<div>McGRATH SUB-REGIONAL HEALTH CENTER</div> <div>COVER SHEET & INDEX</div>		FILE NAME:	
		PROJECT NO:	0198
		PROJ ARCH:	BK
DATE:	4/20/2009		
SCALE:	AS NOTED		
DRAWN BY:	CFP		
SHEET G-001			
1 OF 16

McGrath Health Clinic RFI #: 08
(PROJECT)
Hollow Metal submittal review June 30, 2010
REFERENCE: (DRAWING OR SPEC.) (DATE)

M5.1 detail 3 November 2, 2010
REFERENCE: (DRAWING OR SPEC.) (DATE)

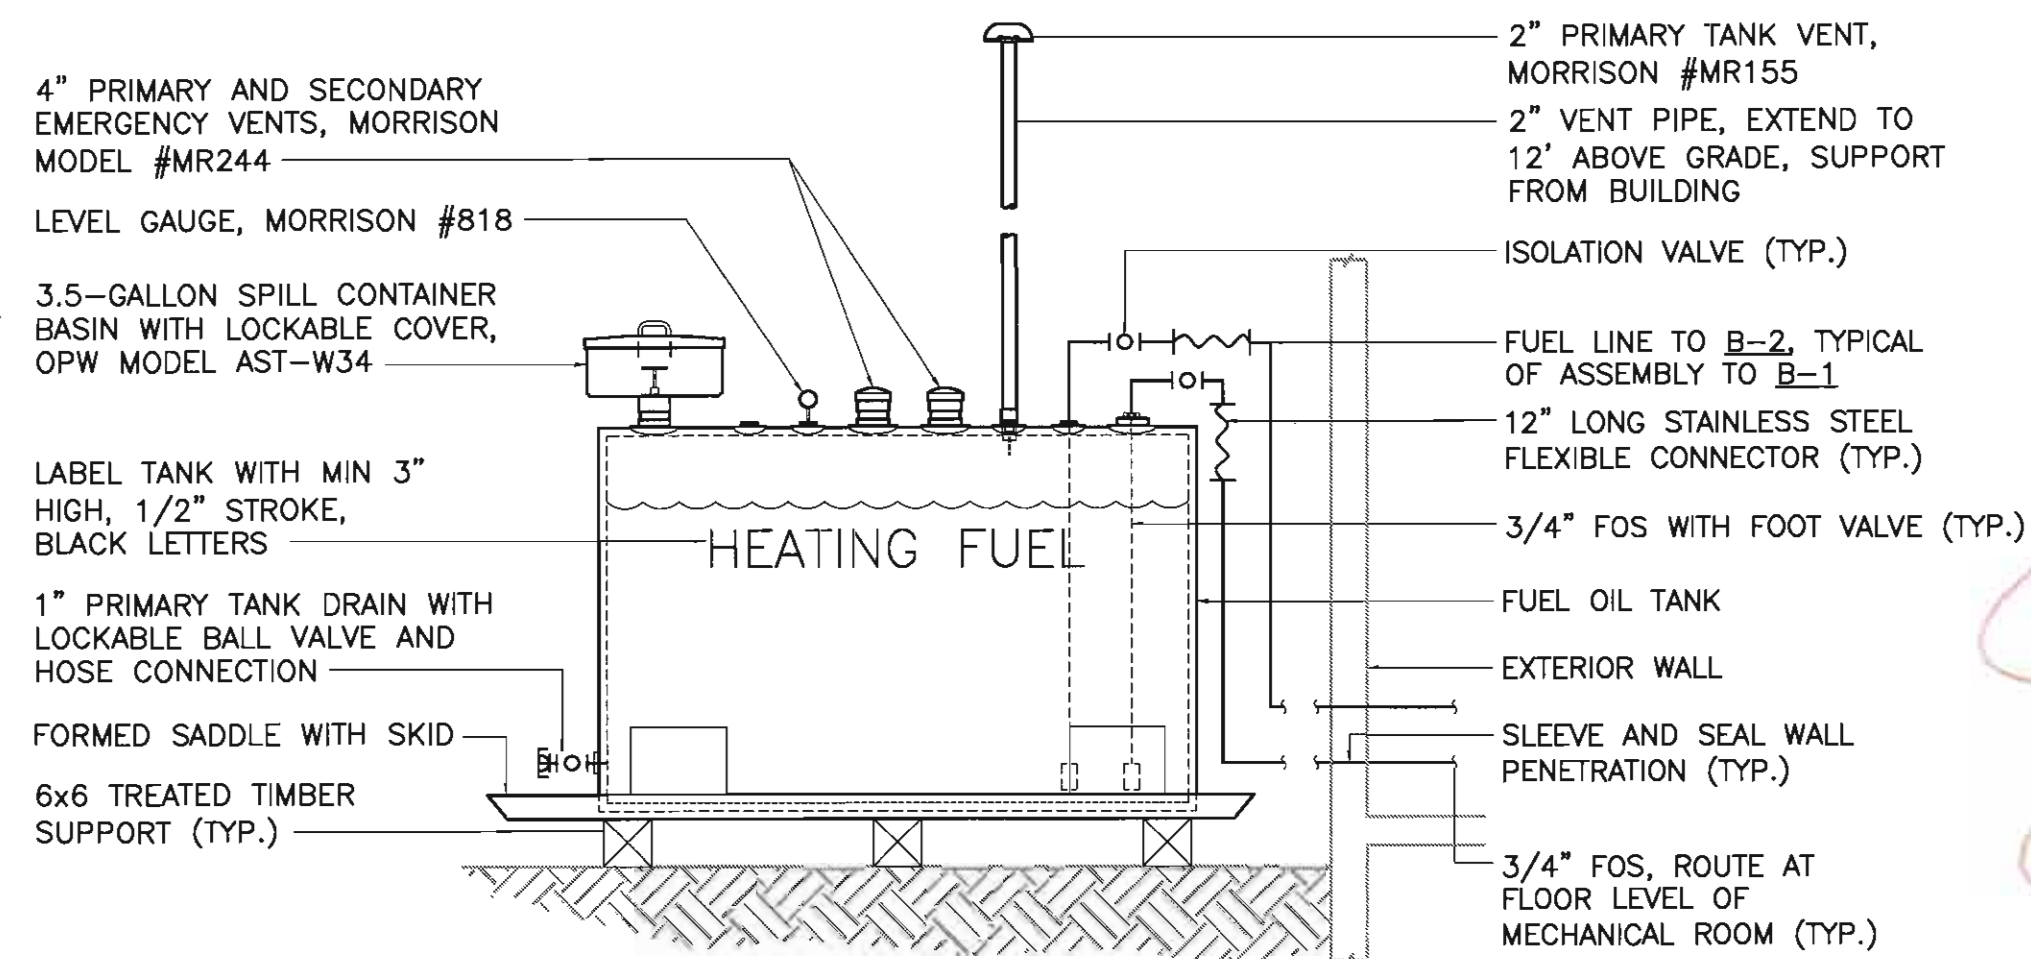
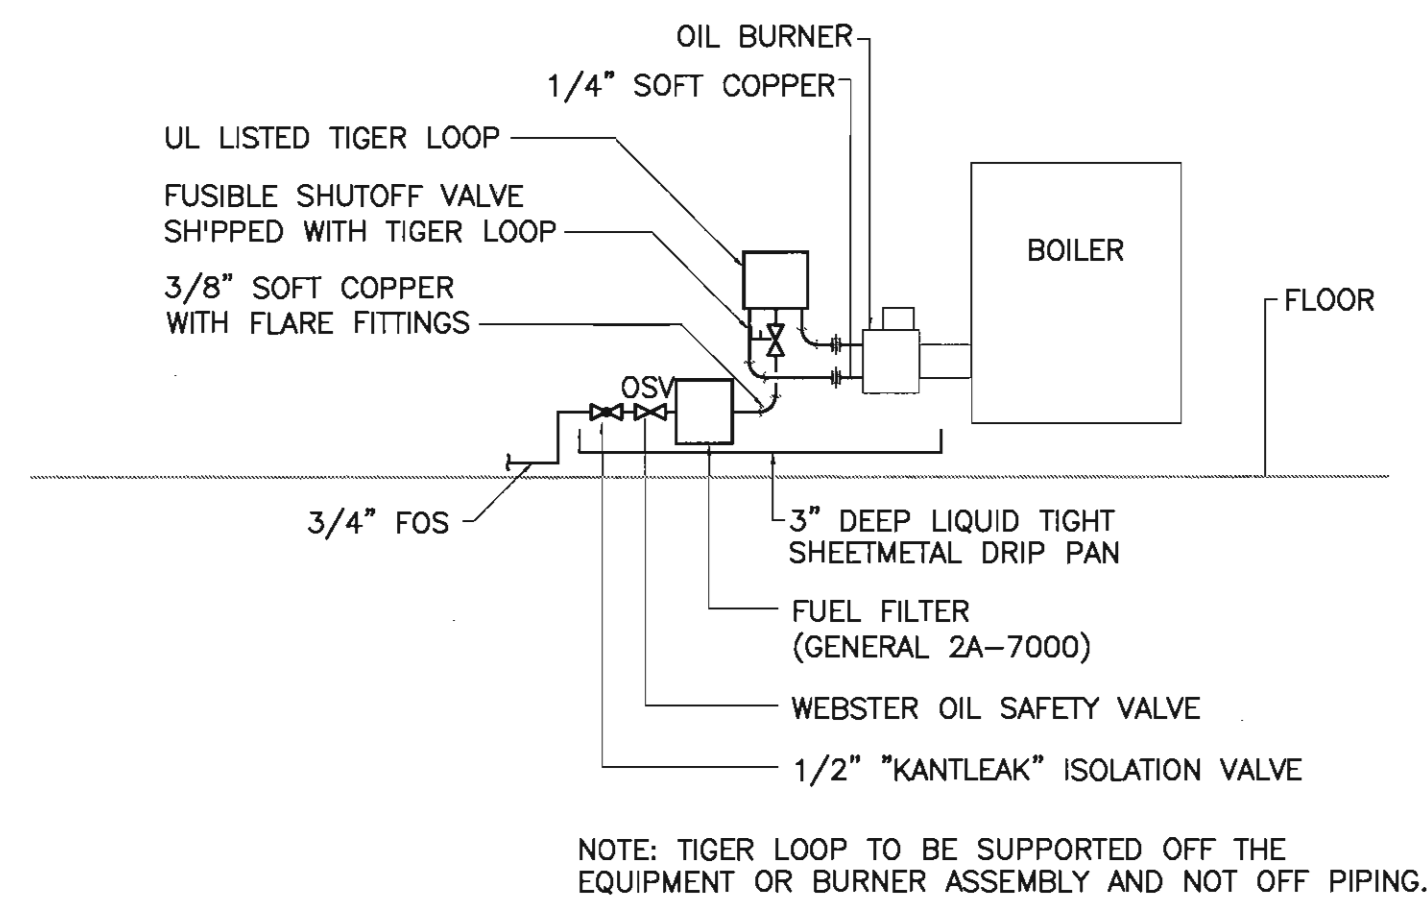
DESCRIPTION: detail 3 on sheet M 5.1 does not show balance valves on the CUH's
however the equipment schedule calls out flows for these. Are balance valves required?

Per 15120 3.01.0 a balance valve is required. Install balance valve upstream of the isolation
valve on the return piping.

1 CRAWLSPACE LIGHTING AND POWER PLAN
E2.2 SCALE: 0 2' 4' 6'
1' 3' 5'

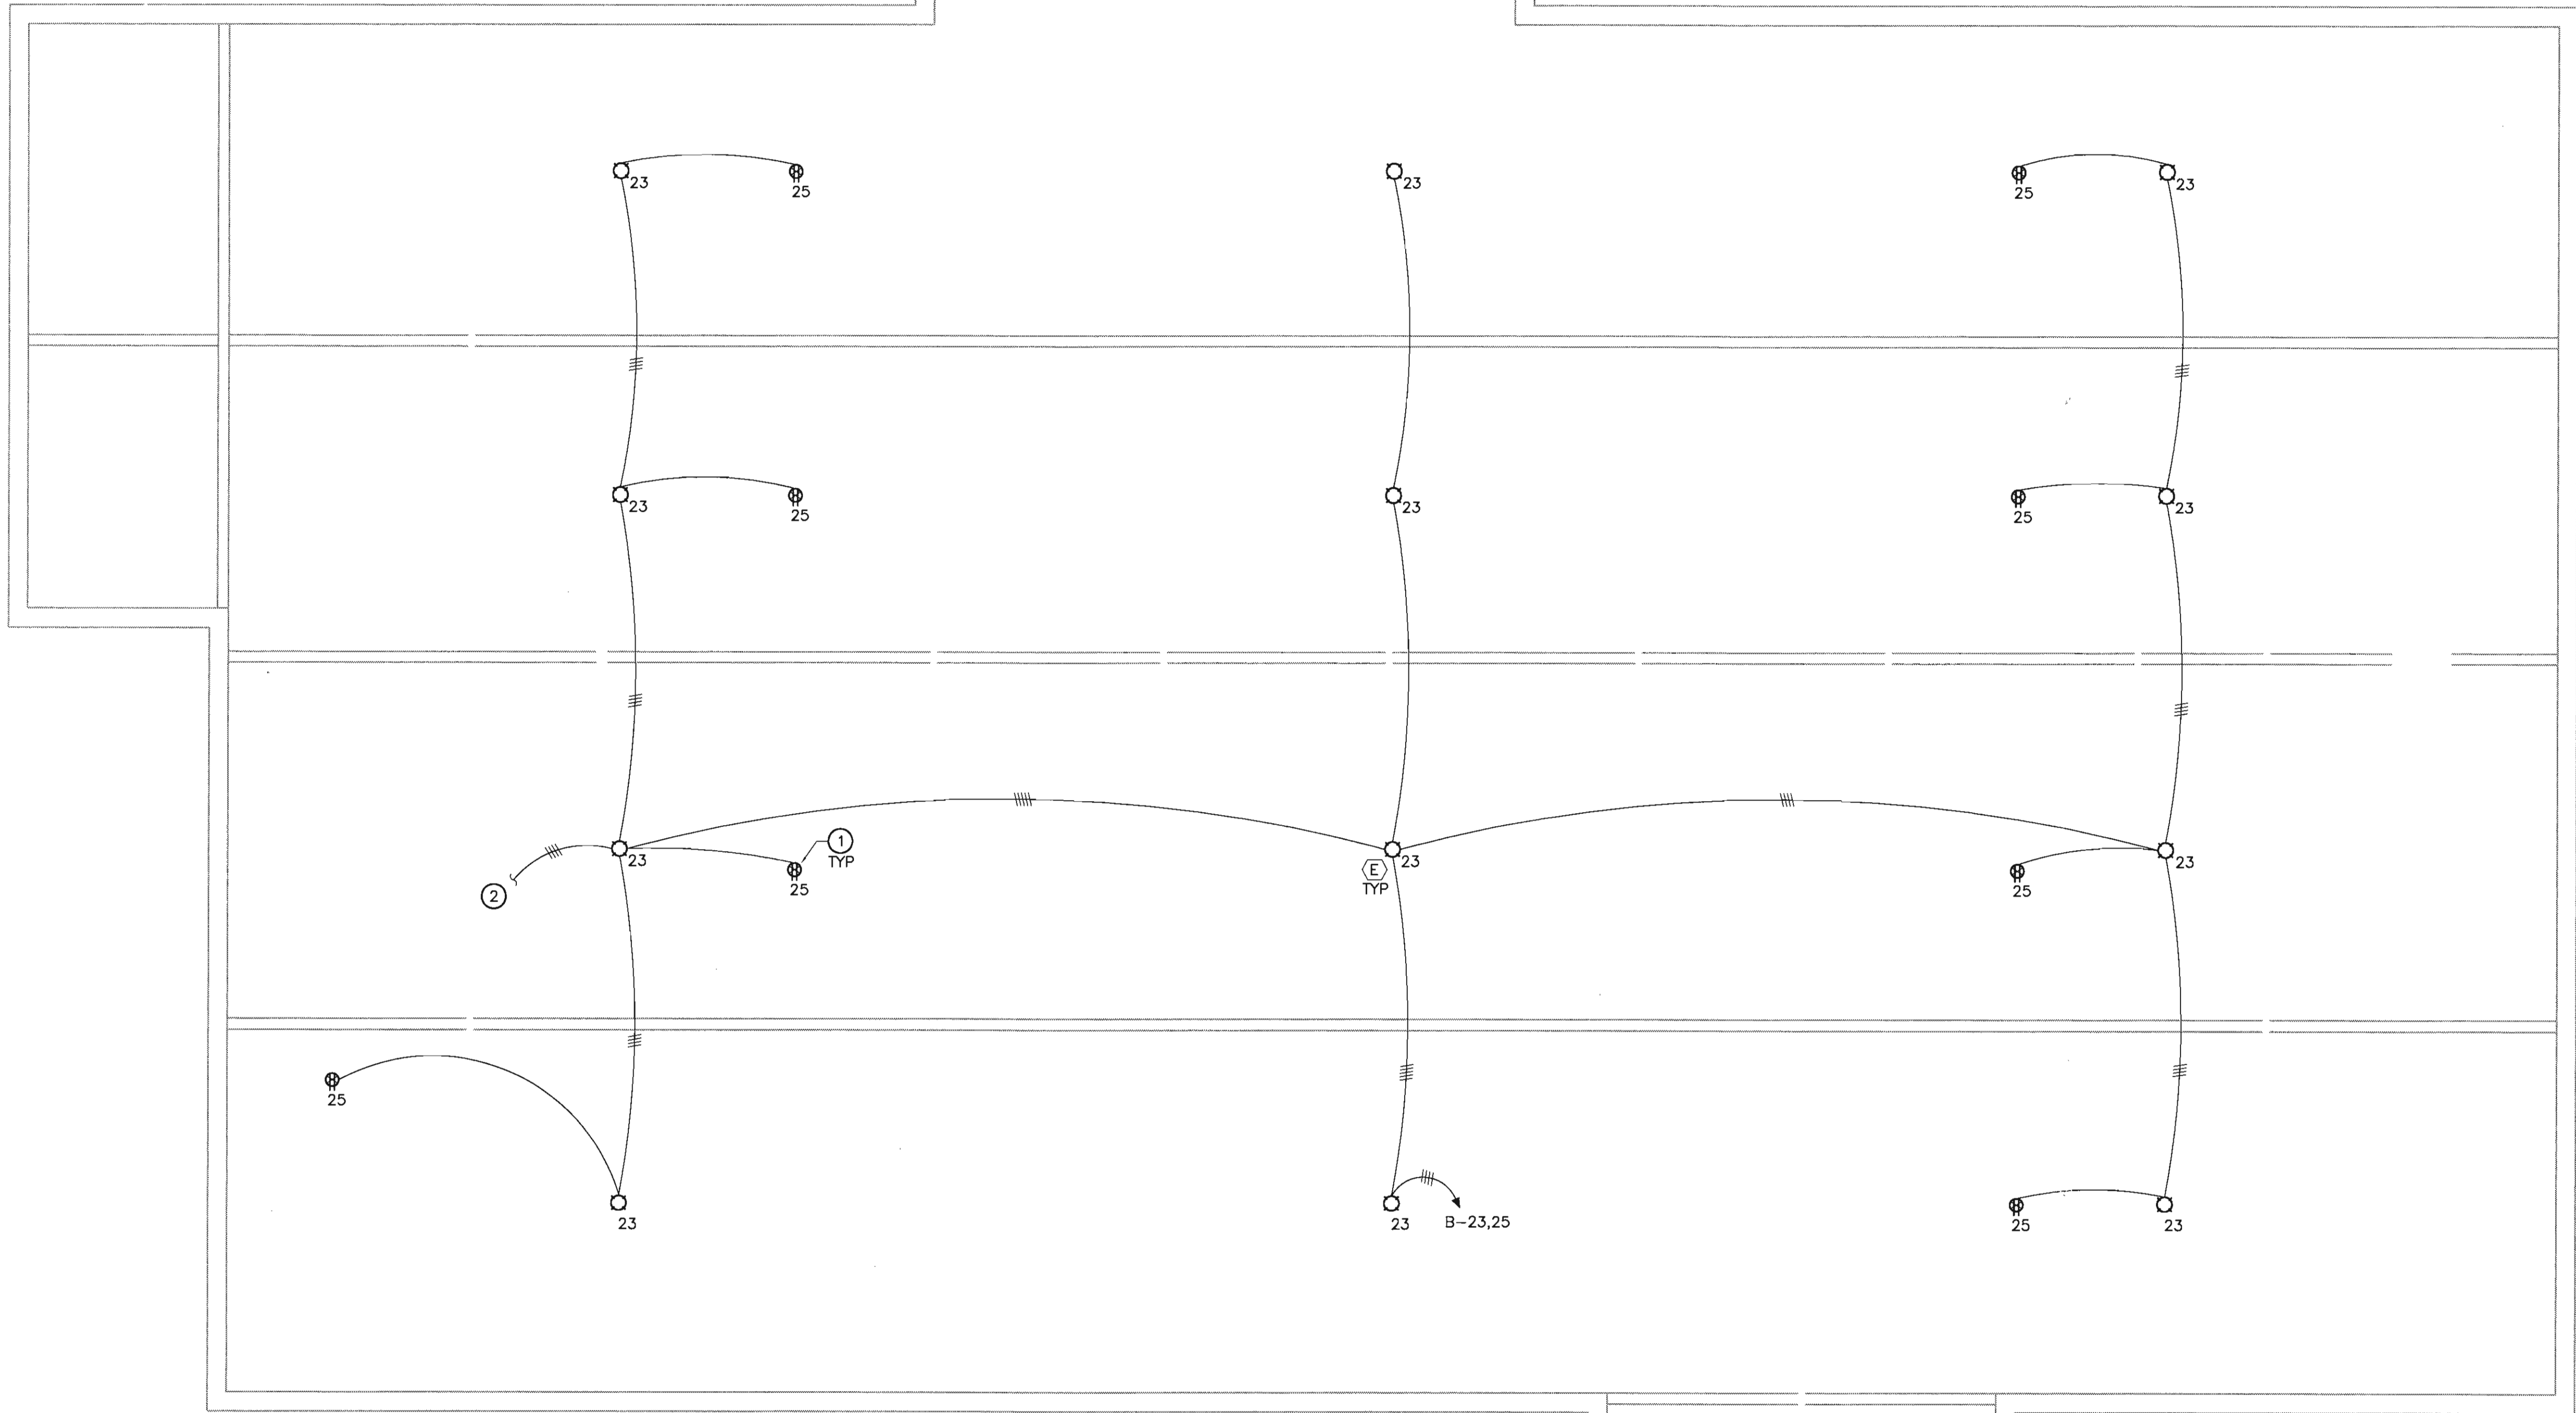
2. Sheet E2.2 -Crawlspace Lighting and Power Plan: **ADD** junction box and disconnect in crawlspace along inside face of north foundation wall at Gridlines B and approximately 3.3 with homerun (1/2" conduit with 3#12AWG) to "M-23 via pilot light switch". **ADD** note symbol 3 adjacent to the new junction box and disconnect.

3. Sheet E2.2 -Crawlspace Lighting and Power Plan, Sheet Notes: **ADD** note 3; "Junction box and disconnect for branch circuit connection to civil arctic piping heat trace. Install heat trace and all required appurtenances per specification section 16123 to heat trace underground sewer arctic piping as shown and indicated in the civil documents. Coordinate with civil for exact location, lengths, and requirements. Access to junction boxes and heat trace shall be provided so that heat trace can be replaced without demolition of adjacent materials. Heat trace shall be connected to and controlled by a single pole pilot light switch to be located in the mechanical room. Provide identification at pilot light switch."
